## PROPOSED COFFS HARBOUR CULTURAL AND CIVIC SPACE DEVELOPMENT KNOWN AS “ALL WELCOME”

Report Ref: 19-212472\_Cap\_Stat\_Report\_R02a

Date: 18 June 2019

## Building Code of Australia 2019 Comments

GROUND LEVEL FLOOR  
PLAN

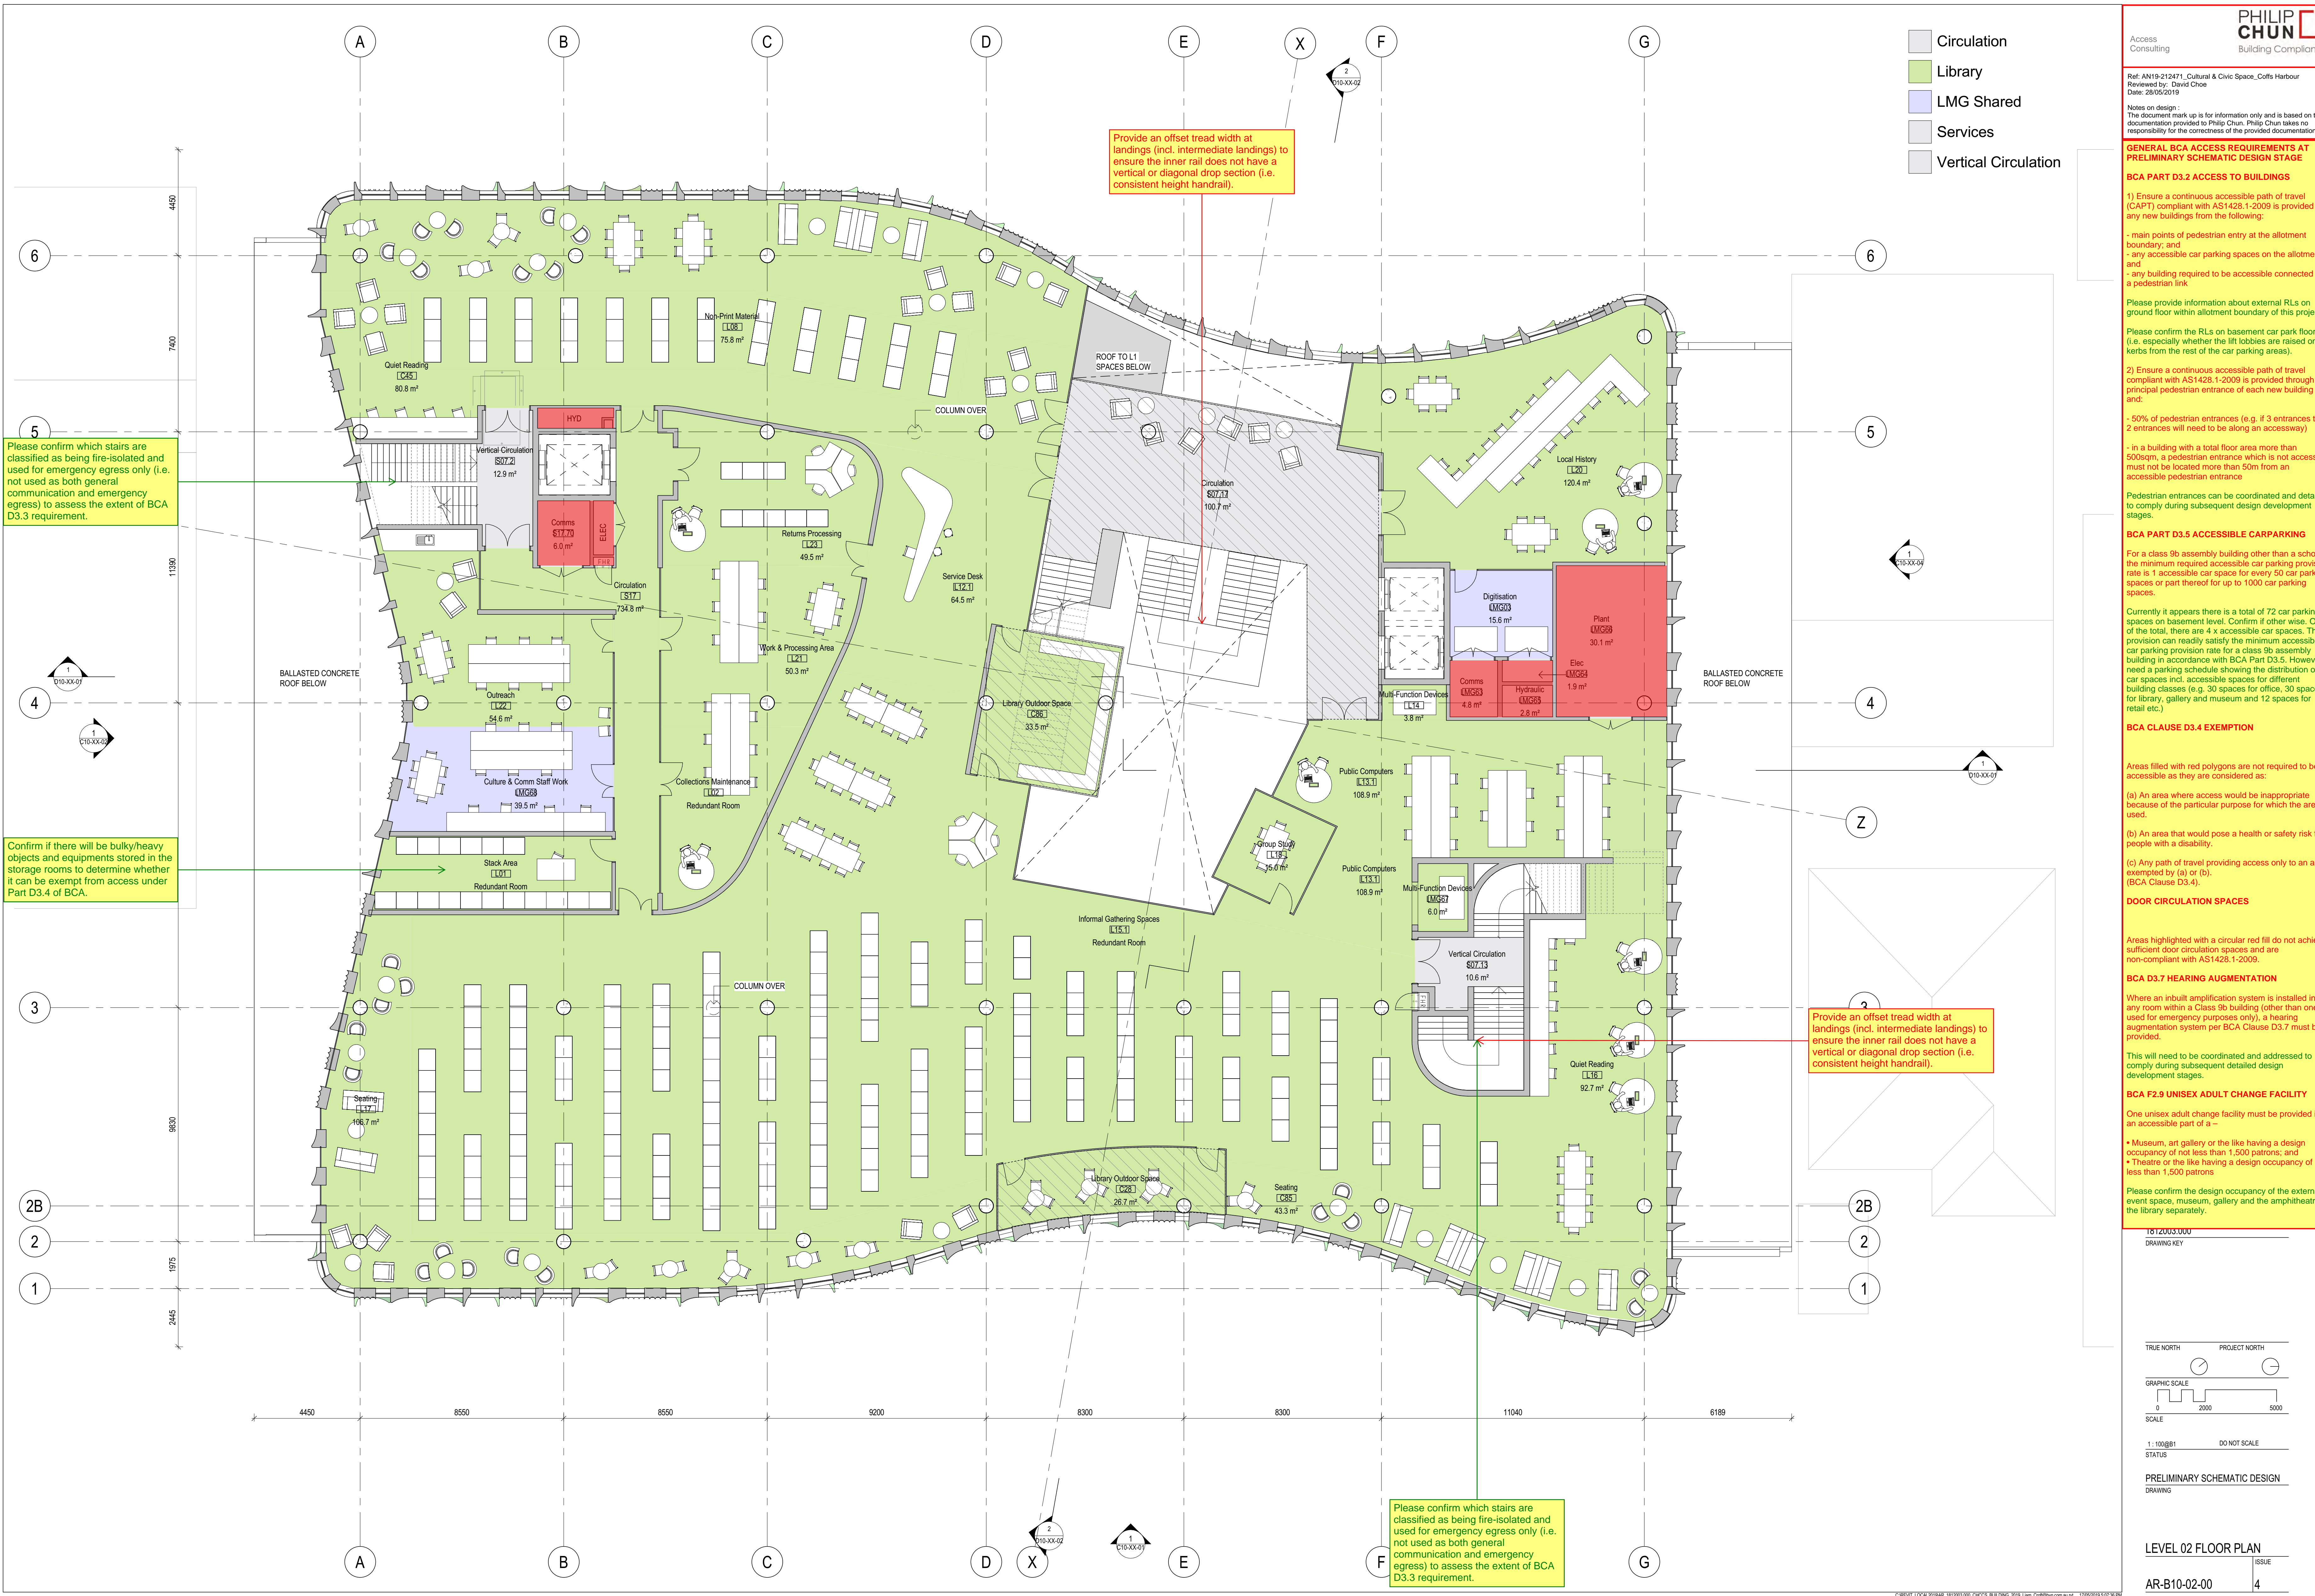
Please confirm which stairs are classified as being fire-isolated and used for emergency egress only (i.e. not used as both general communication and emergency egress) to assess the extent of BCA D3.3 requirement.

Please confirm use of this room to determine whether it can be exempt from access under Part D3.4 of BCA.

Need 530mm latch-side clearance for a frontal approach to the sliding door for compliance with AS1428.1-2009.

Need to provide separate male and female ambulant that are compliant with AS1428.1-2009.

LEVEL 03 FLOOR PLAN

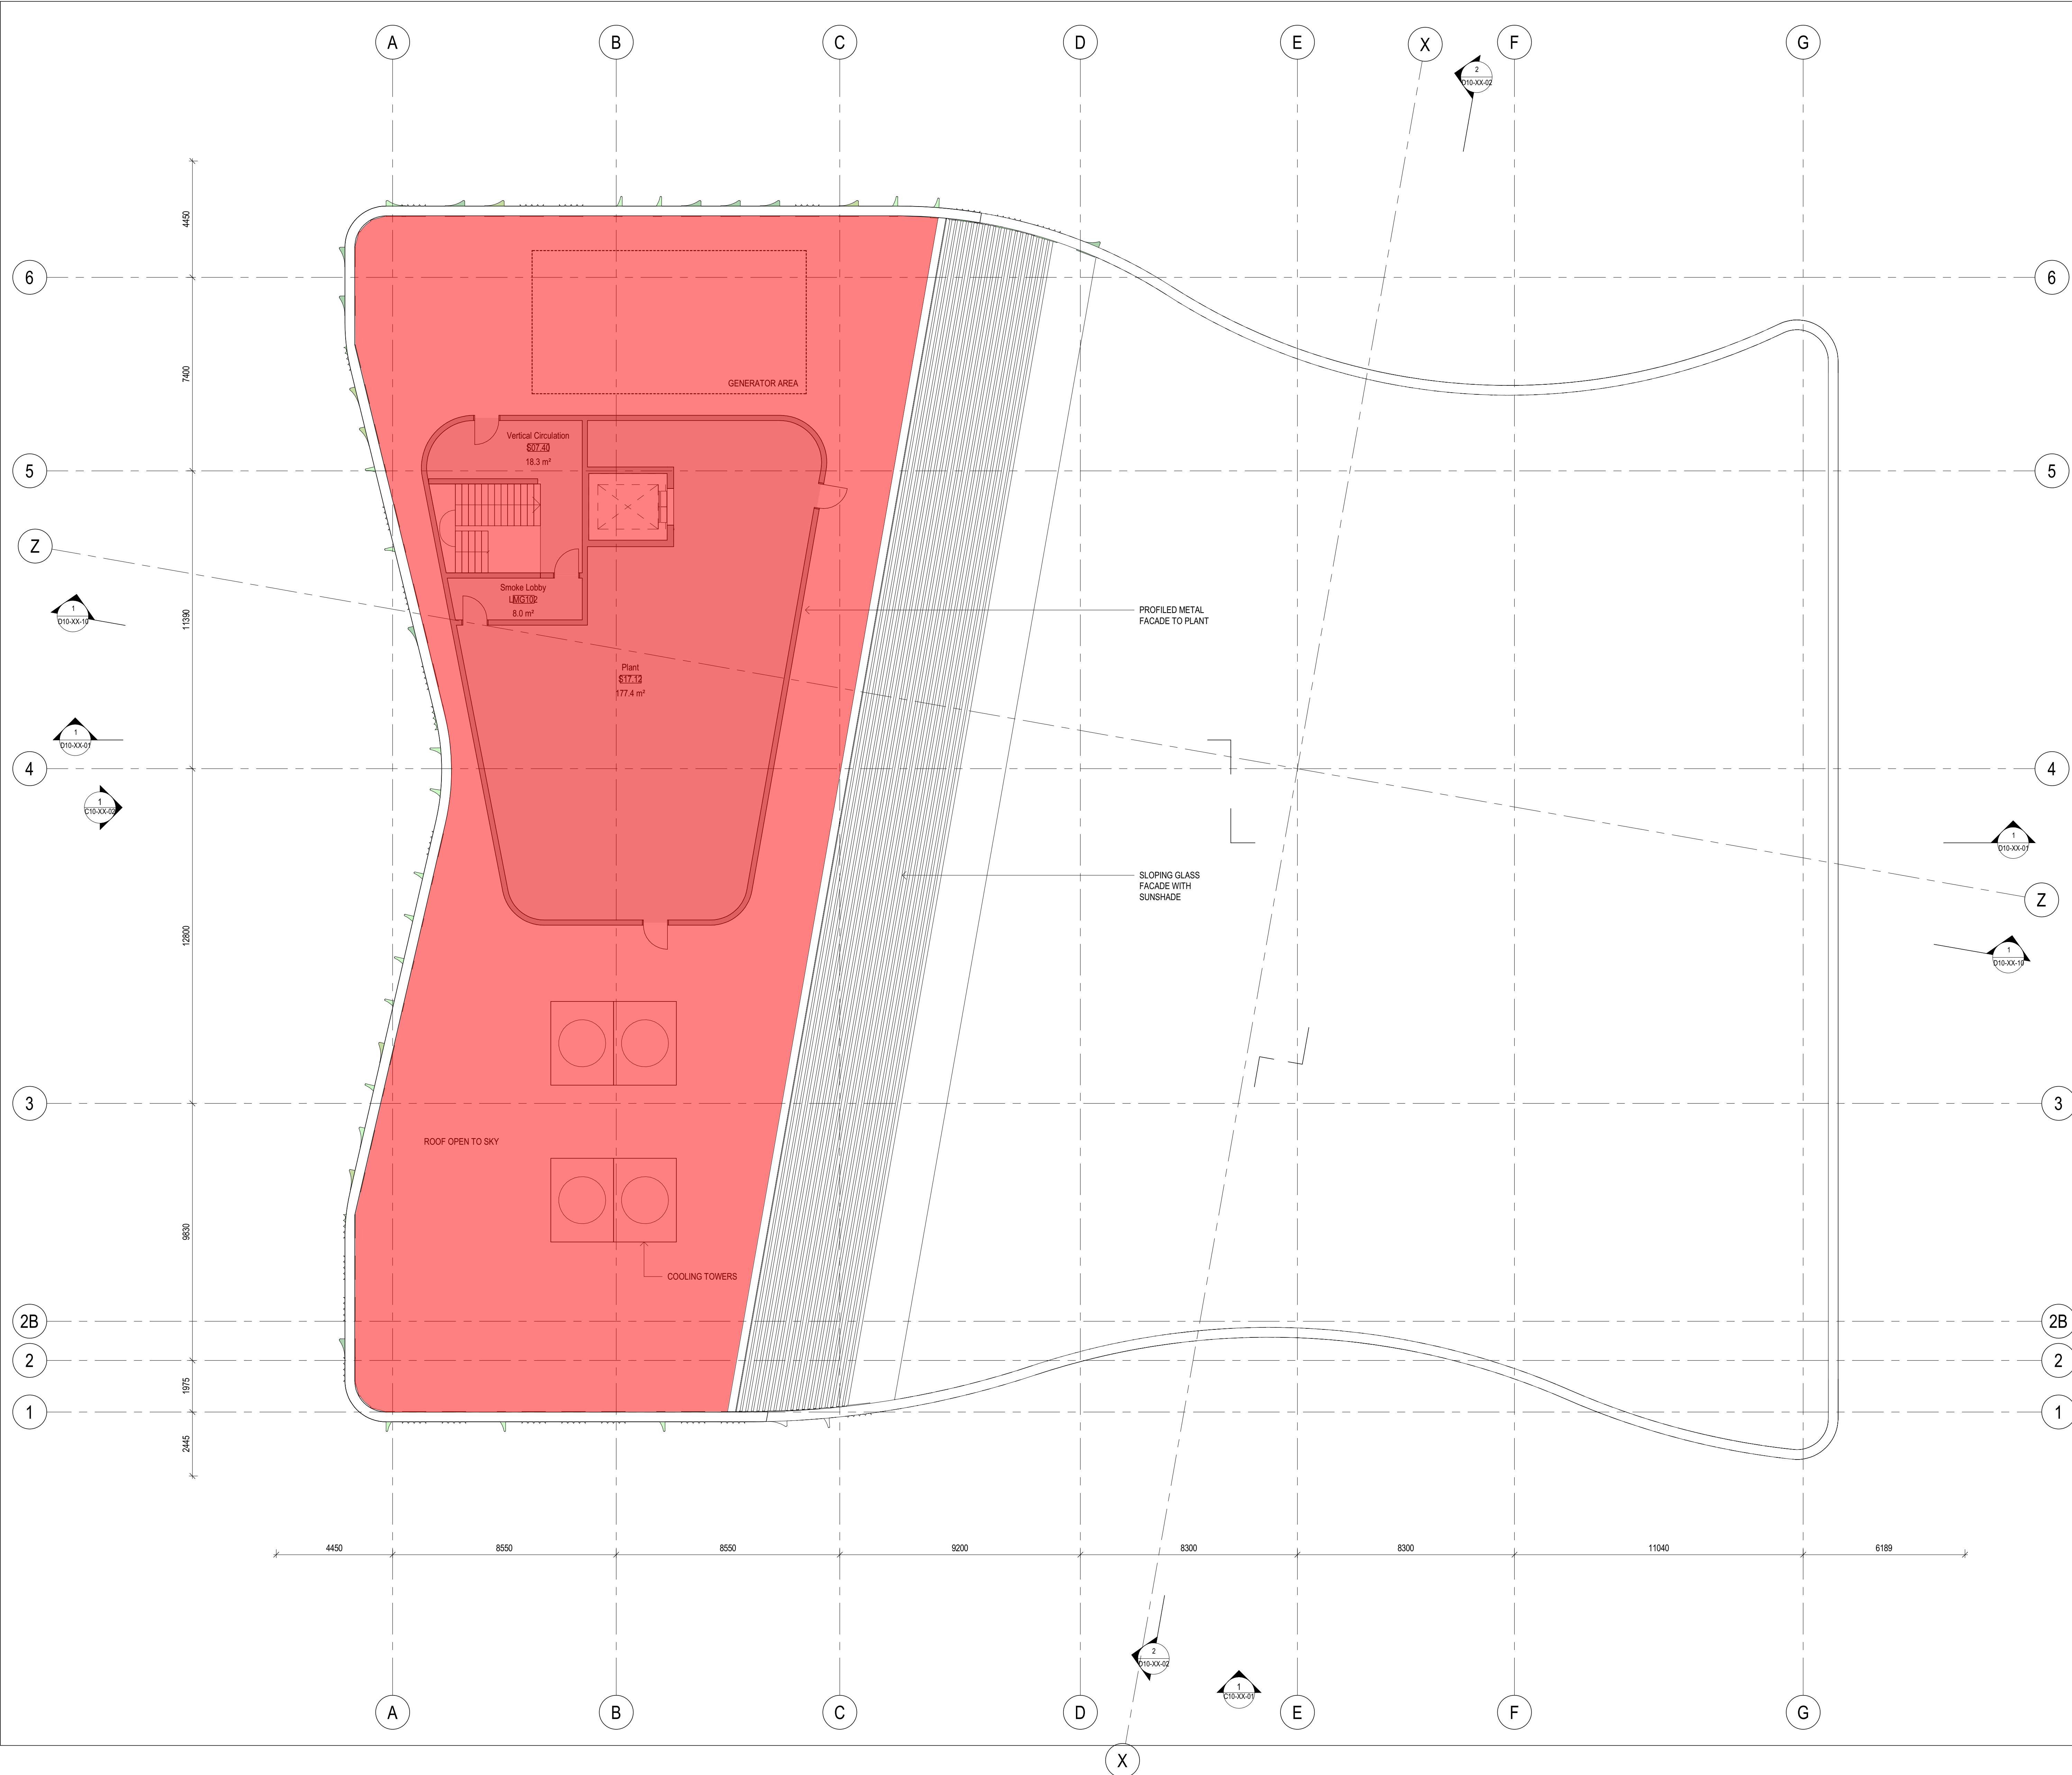
Please provide information about external RLs on ground floor within allotment boundary of this project.  
Please confirm the RLs on basement car park floor (i.e. especially whether the lift lobbies are raised on kerbs from the rest of the car parking areas).

SECTION N-S

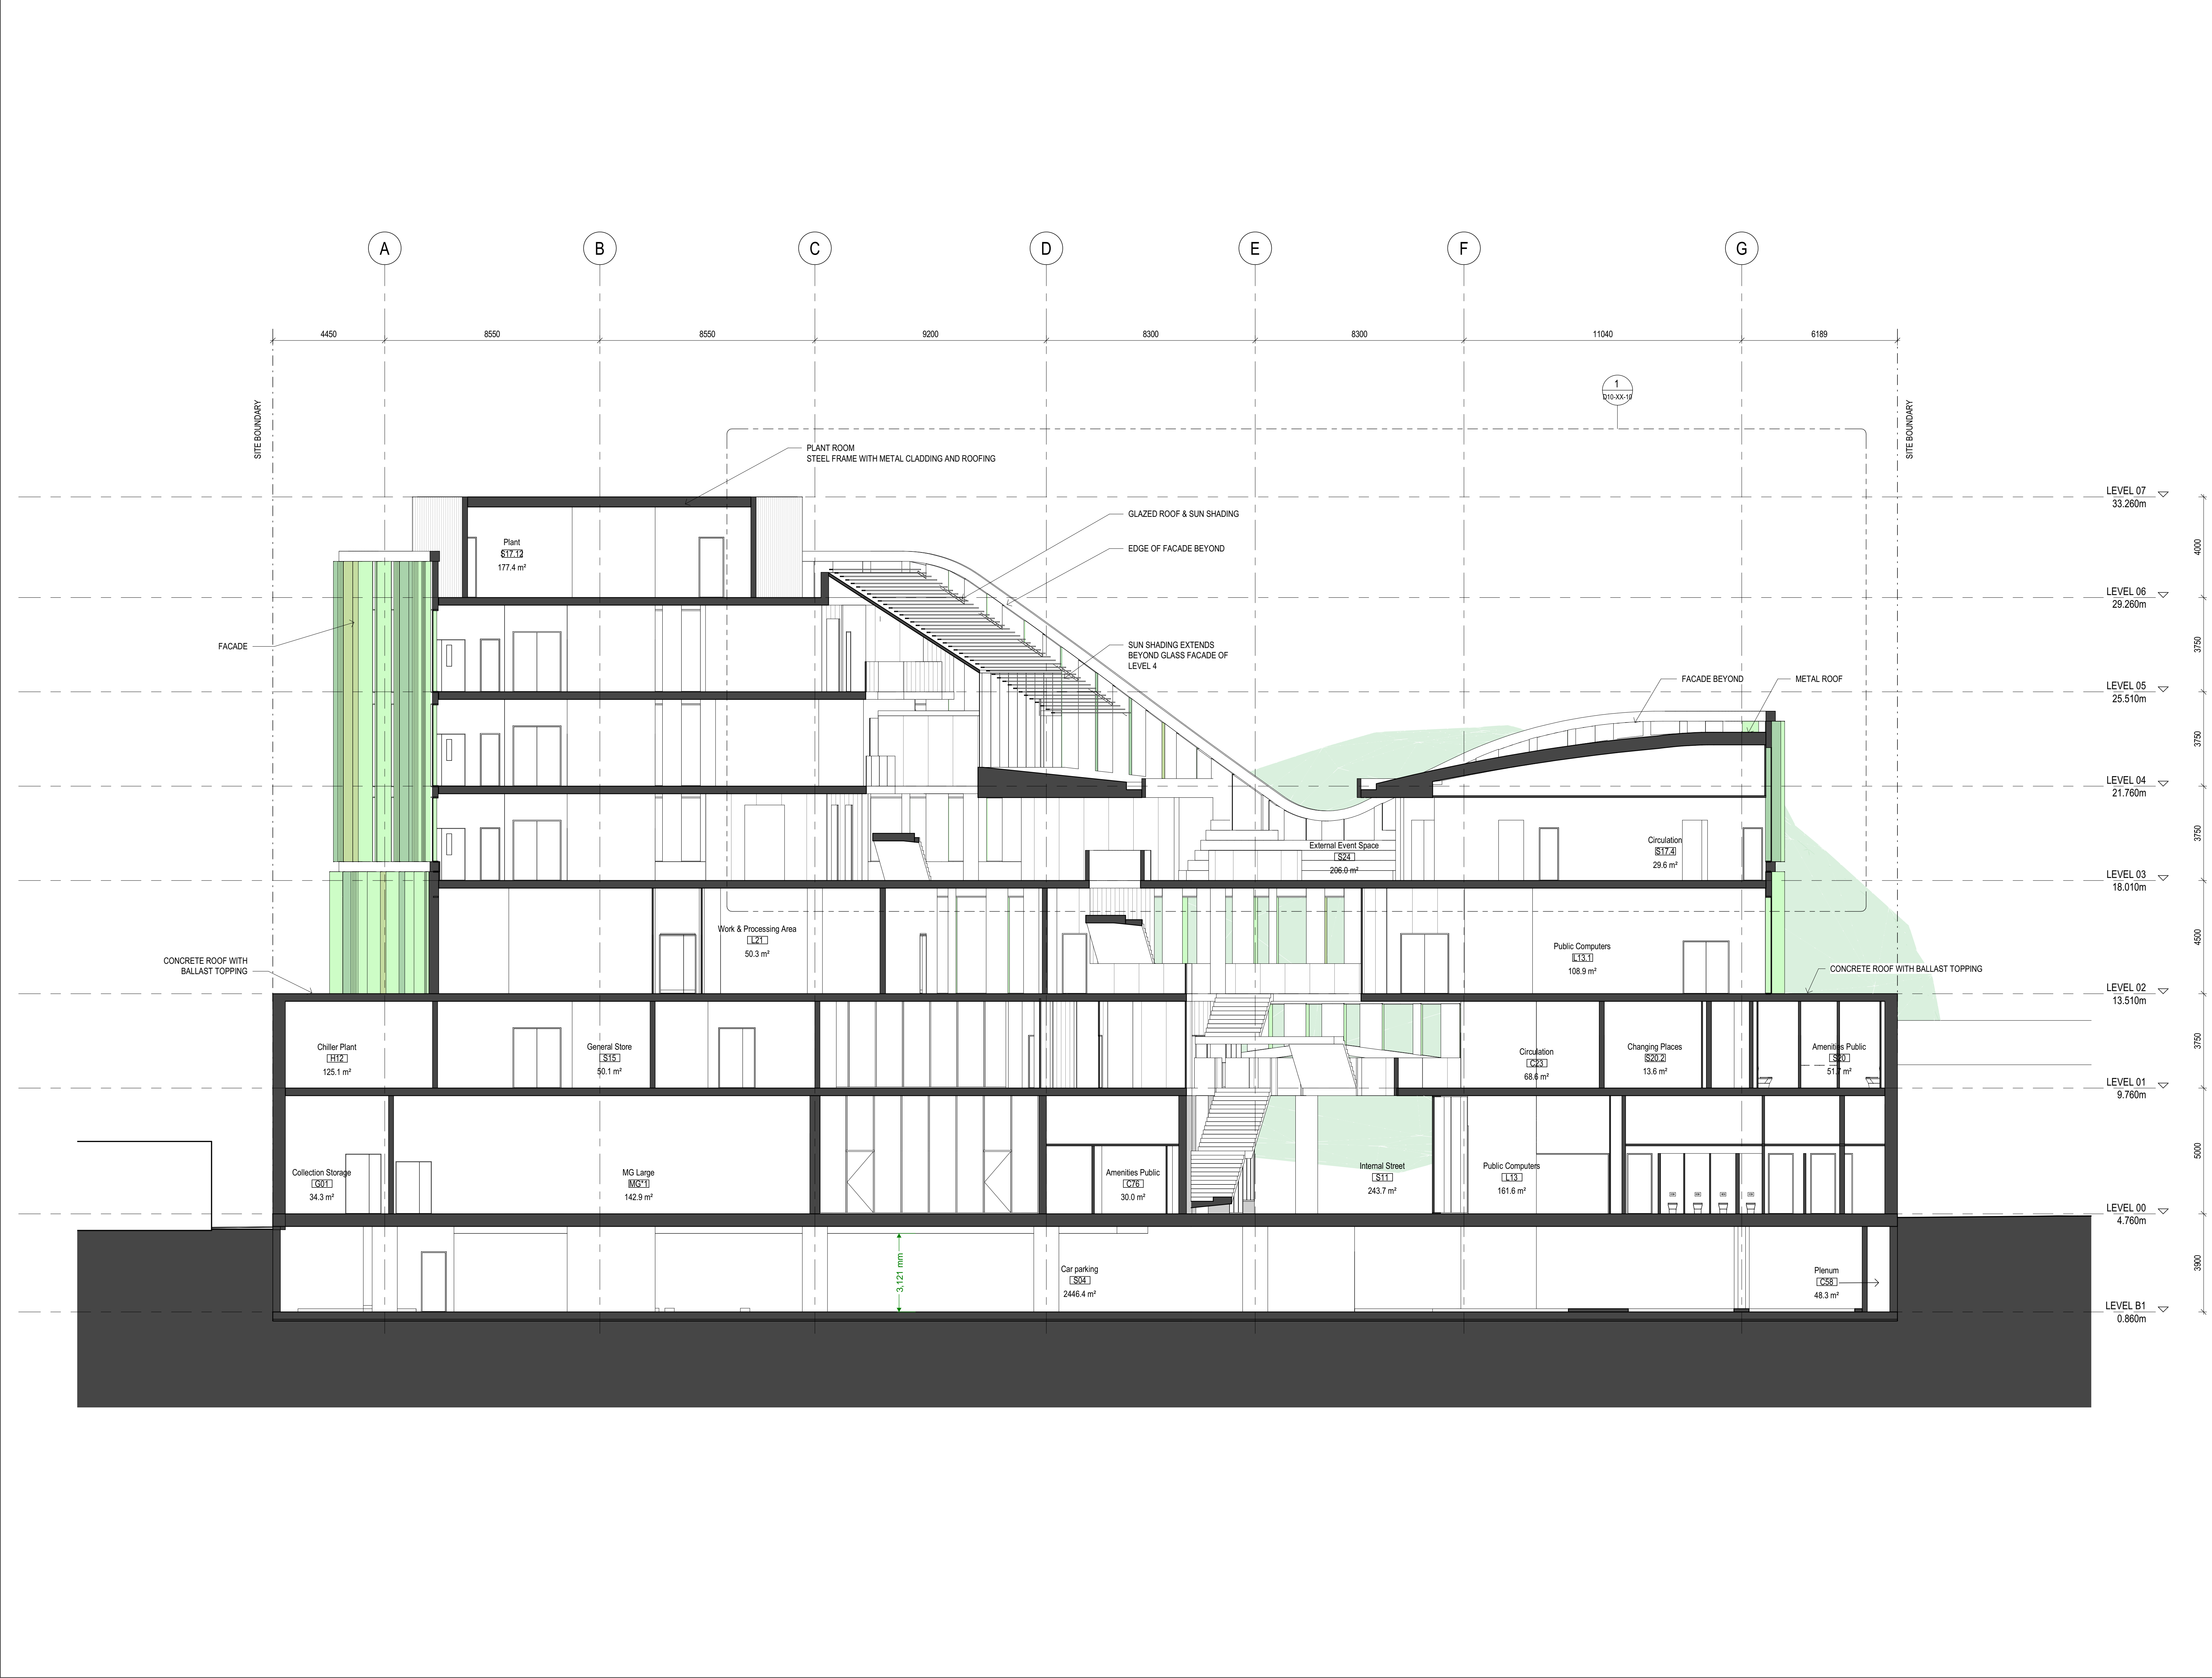
Please provide information about external RLs on ground floor within allotment boundary of this project.
